Eliminating Noise Symptoms - Replacing Exhaust Pipes (Humming noise from around exhaust system 20/16)

Revision: This bulletin replaces ATI Group 2, #1503, dated July 23, 2015.

Vehicle Type: **Macan S, Macan GTS, Macan Turbo**

Cause - exhaust system

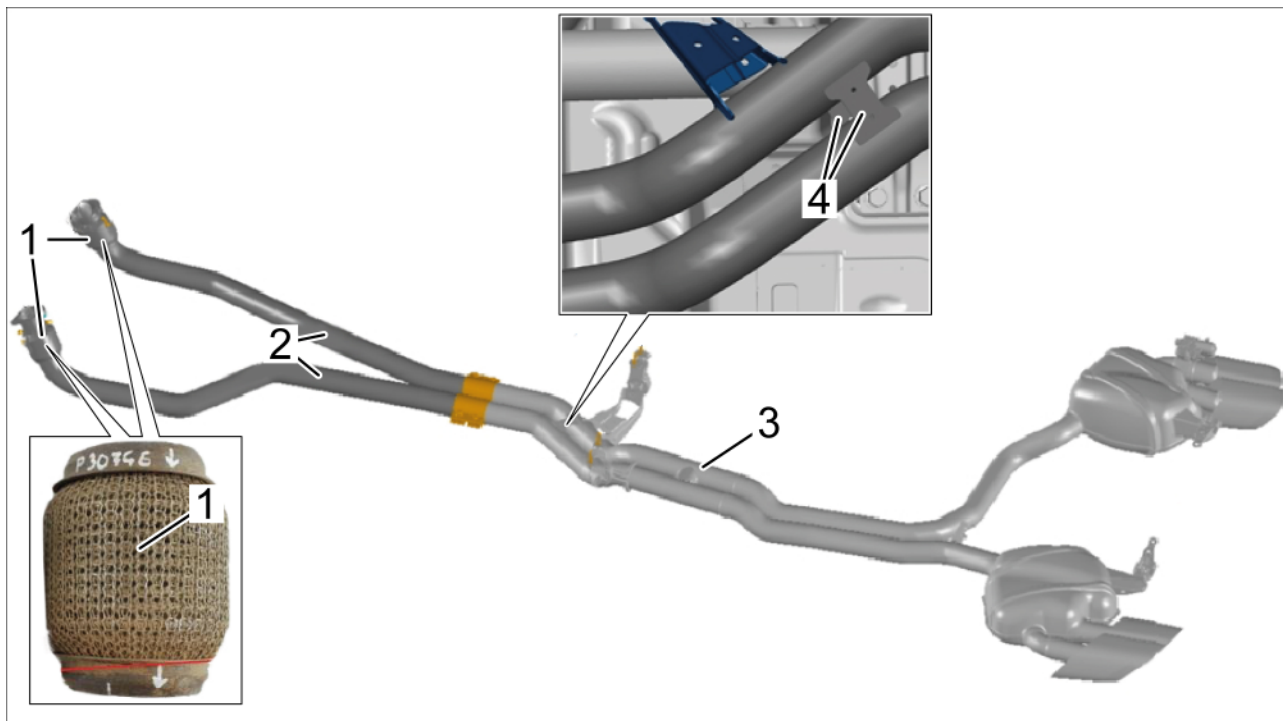
Cause: The dynamic rigidity of the decoupling elements ⇒ *Cause - exhaust system -1-* on the exhaust gas connecting tubes ⇒ *Cause - exhaust system -2-* is too low. Due to lack of insulation, the filler plates ⇒ *Cause - exhaust system -4-* on the rear exhaust pipe ⇒ *Cause - exhaust system -3-* can break.

Remedial Action: In the event of a customer complaint, only the exhaust gas connecting tubes must be replaced and **new** connecting tubes with modified decoupling elements must be fitted.

If the filler plates on the rear exhaust pipe are broken, remove the filler plates.

Exhaust system

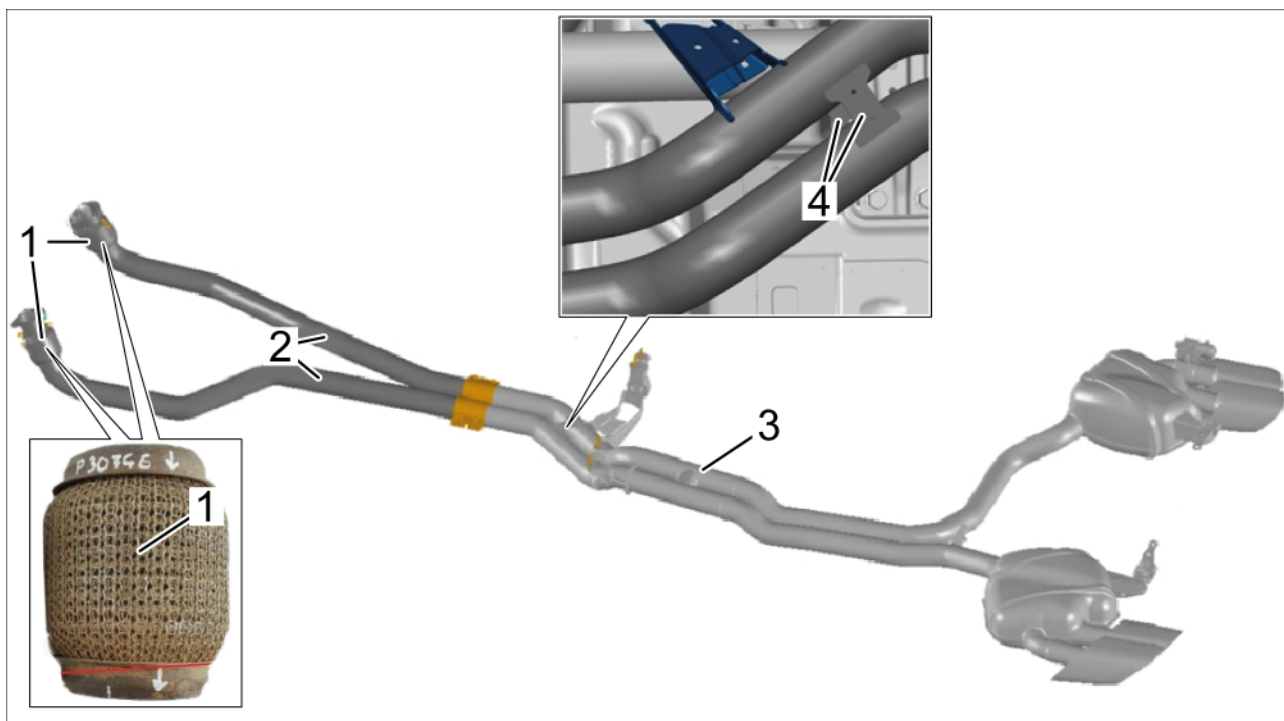
- 3 Check filler plates ⇒ *Exhaust system -4-* on the rear exhaust pipe ⇒ *Exhaust system -3-*.
 - 4 If filler plates ⇒ *Exhaust system -4-* are broken, remove filler plates ⇒ *Exhaust system -4-*.

- 5 Secure new exhaust gas connecting tube at the left and right ⇒ *Exhaust system -2-* (check part number of **new** connecting tubes) to the catalytic converters.

- 6 Assemble exhaust gas connecting tube at the left and right ⇒ *Exhaust system -2-* and rear exhaust pipe ⇒ *Exhaust system -3-*. ⇒ *Workshop Manual '260119 Removing and installing exhaust system'*
